Number: DSB 14-0015

Title: Variable Speed Inverter/AOC Board Rework

Bryant: 189BNV, 288BNV
Carrier: 24VNA9, 25VNA8

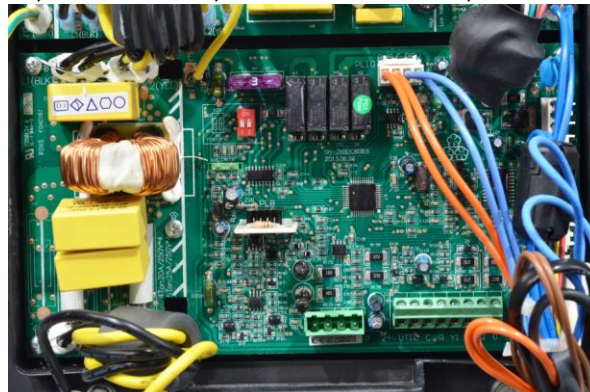
2. Remove control box door

Loosen

Remove

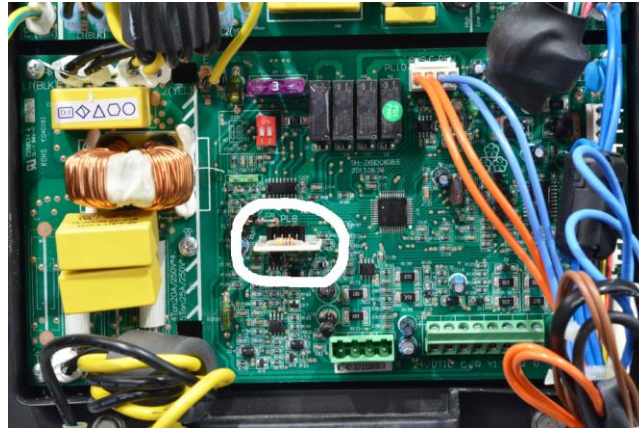
4. Unplug 8 harness from the AOC board for removal (PL10: RVS/PEV, PL20: MOC/AOC, PL5: EXV if H/P, PL19: SPT, PL17: OST, PL16: ODT, PL15: OCT/OAT, and PL18: ABCD).

5. Remove the four screws in each corner to remove board from inverter housing.

***** MAKE SURE TO REMOVE AND REPLACE THE MODEL PLUG (PL8 shown below in white circle) FROM THE EXISTING BOARD AND REINSTALL ON NEW REPLACEMENT BOARD. *****

6. Reinstall (4) board screws, reconnection 8 harnesses to new AOC board, check for model plug, replace the unit's control box cover with 4 screws and retighten 2 screws at top of unit.
7. Repackage or reconnect power for normal operation.
